# UNITED STATES PATENT AND TRADEMARK OFFICE

APPLICATION NO.	FILING DATE	FIRST NAMED INVENTOR	ATTORNEY DOCKET NO.	CONFIRMATION NO.
10/680,070	10/06/2003	Keith E. Myers	816020-100046-US	9949
34026	7590	10/13/2005	EXAMINER	
JONES DAY			MILLER, CHERYL L	
555 SOUTH FLOWER STREET FIFTIETH FLOOR			ART UNIT	
LOS ANGELES, CA 90071			PAPER NUMBER

# Office Action Summary

FIG. 8

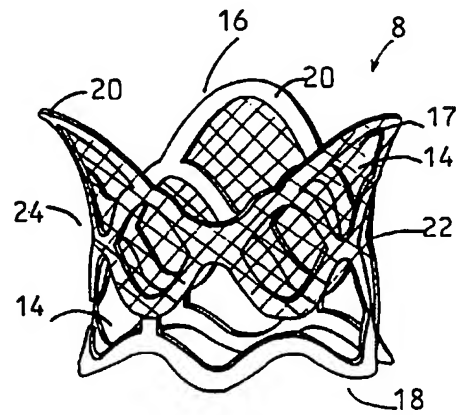
@ least three  
elliptical members  
shown in red →
